Replacing your 1771-ICD modules with 1771sc-ICI16

Application Note: 2/28/06-1

1771-ICD Wiring

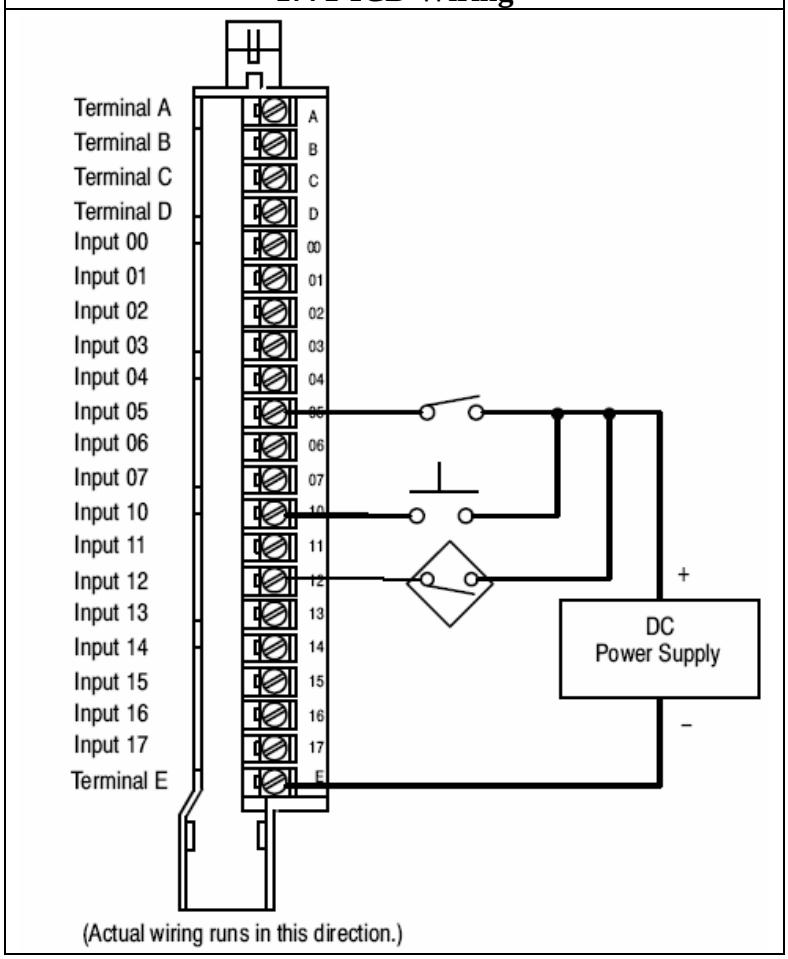
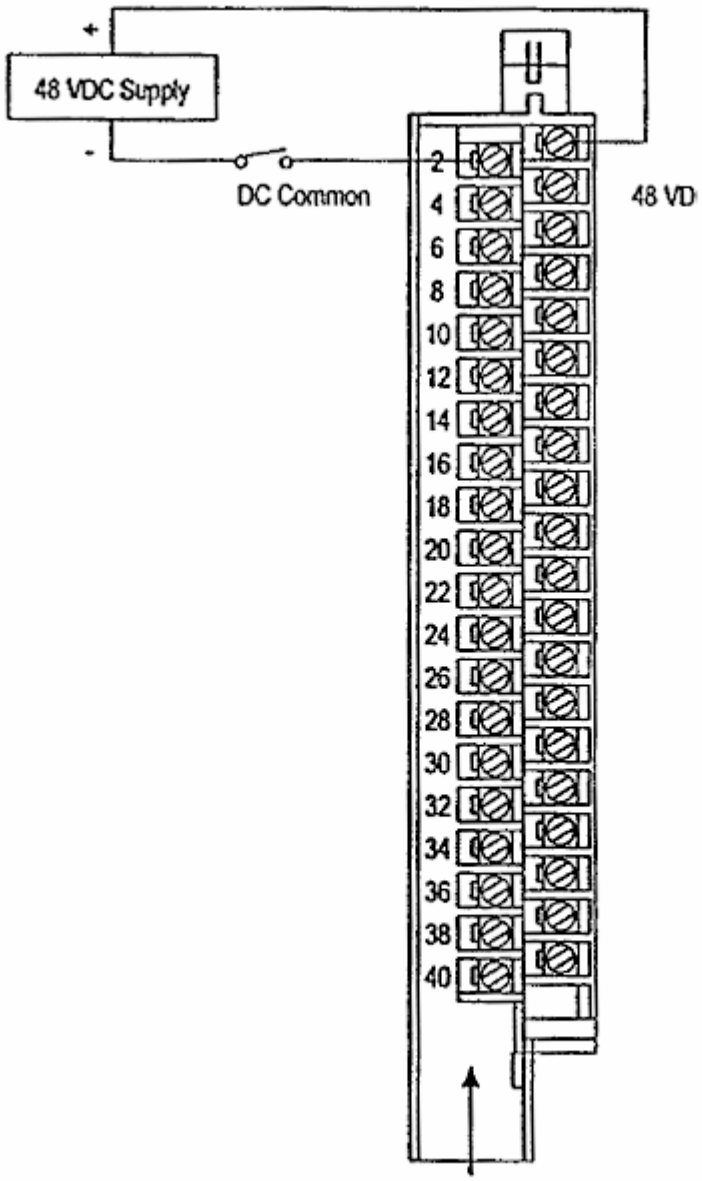
The 1771sc-ICI16 offers the same functionality of the 1771-ICD and may be used as a replacement. The 1771sc-ICI16 offers 16 channels of input with channel-to-channel-isolation for additional noise suppression. The two modules are wired differently. Below are the wiring diagrams.

Terminal	Function
1	Input 00 +
2	Input 00 -
3	Input 01 +
4	Input 01 -
5	Input 02 +
6	Input 02 -
7	Input 03 +
8	Input 03 -
9	Not used
10	Not used
11	Input 04 +
12	Input 04 -
13	Input 05 +
14	Input 05 -
15	Input 06 +
16	Input 06 -
17	Input 07 +
18	Input 07 -
19	Not used
20	Not used
21	Input 10 +
22	Input 10 -
23	Input 11 +
24	Input 11 -
25	Input 12 +
26	Input 12 -
27	Input 13 +
28	Input 13 -
29	Not used
30	Not used
31	Input 14 +
32	Input 14 -
33	Input 15 +
34	Input 15 -
35	Input 16 +
36	Input 16 -
37	Input 17 +
38	Input 17 -
39	Not used
40	Not used
